**ZONING MAP CHANGE
STAFF REPORT**

City Council Meeting Date:
June 20, 2017

Site Location: 9001 & 9101 Tehama Ridge Parkway Mapsco: 21x, 35B

To: PD/G Planned Development for all uses in "G" Intensive Commercial plus mini-warehouse; site plan included

SITE PLAN
for
PRESIDIO SELF STORAGE
IN THE PRESIDIO
FORT WORTH, TEXAS

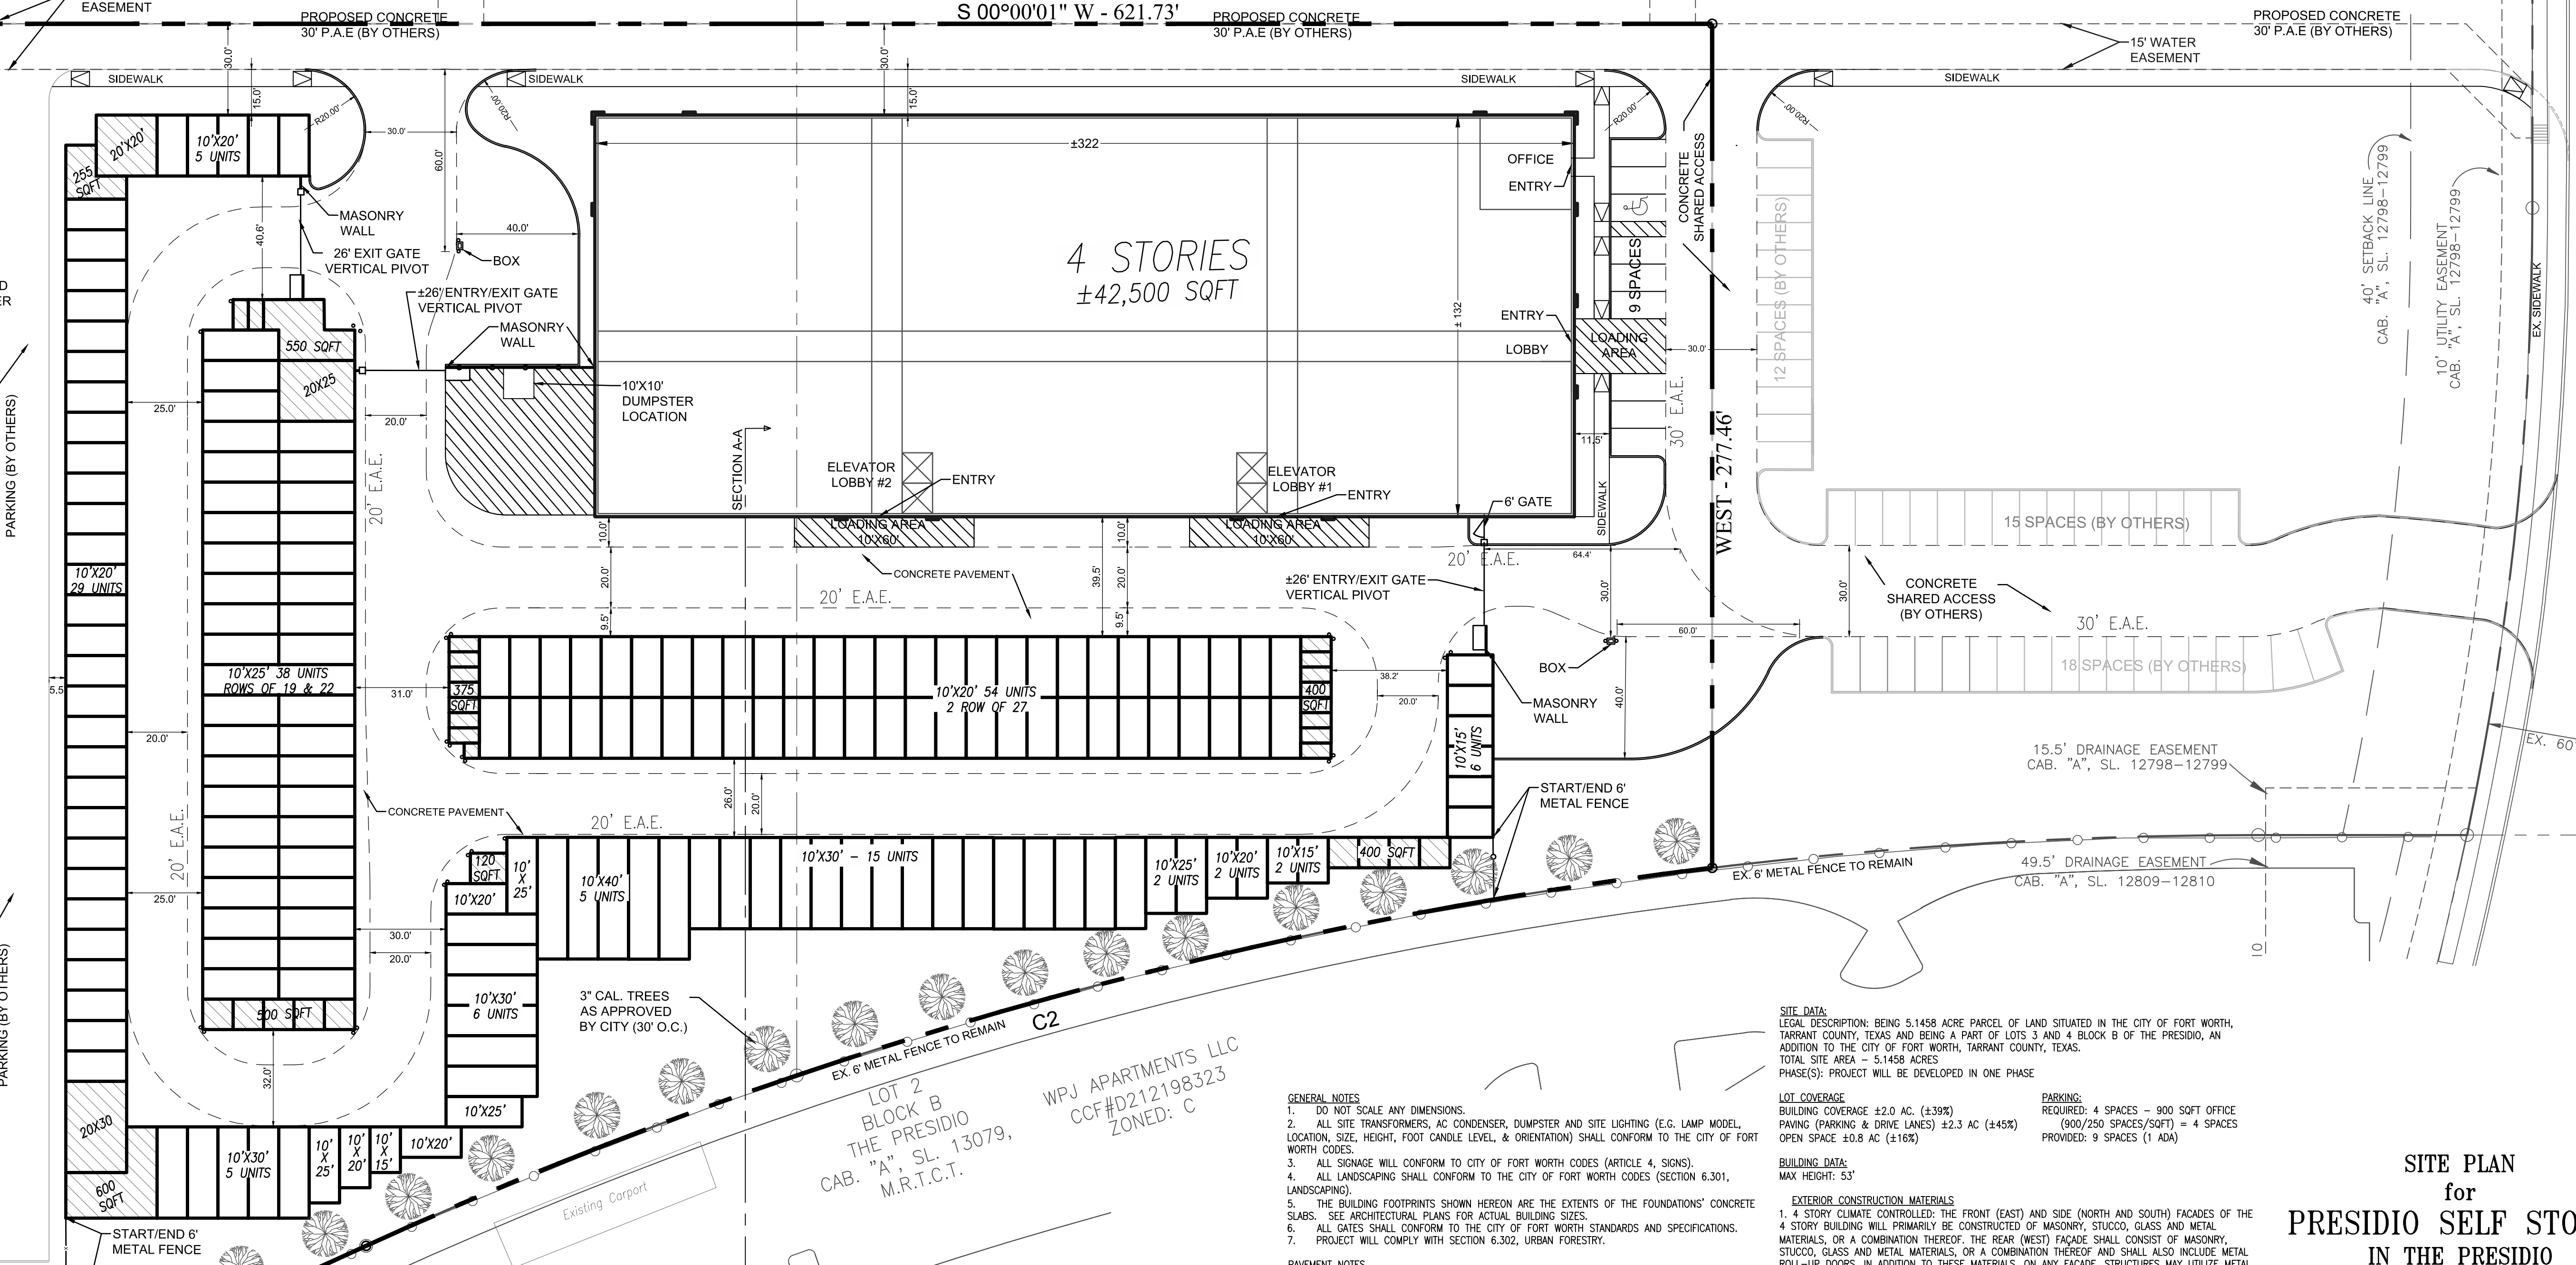
The site plan as submitted is not in general compliance with the zoning regulations. The key deficiencies are:

1. On the west property line an existing 6' metal fence is being requested to remain. **(waiver required)**

1. FYI--This property cannot get a building permit until it is properly platted. A portion of this property lies within the replat FS-16-197. The remaining portion is located on Lot 4, Block B, The Presidio. If this property is going to be platted as its own individual lot, then either revise FS-16-197 to include Lot 4 or a new replat application would have to be made to plat this property as a separate lot.

2. The access for this property is a public access easement being dedicated by FS-16-197 and by separate instrument. Both the plat and the separate instrument must be recorded prior to any building permits being issued for this development.

3. In addition, since this property does not have frontage on either roadway, public utilities must be extended to properly serve this lot with water and sewer. Confirm with the water department that adequate utilities are available for this development.

Zoning Commission recommended a waiver to item #1 noted above.
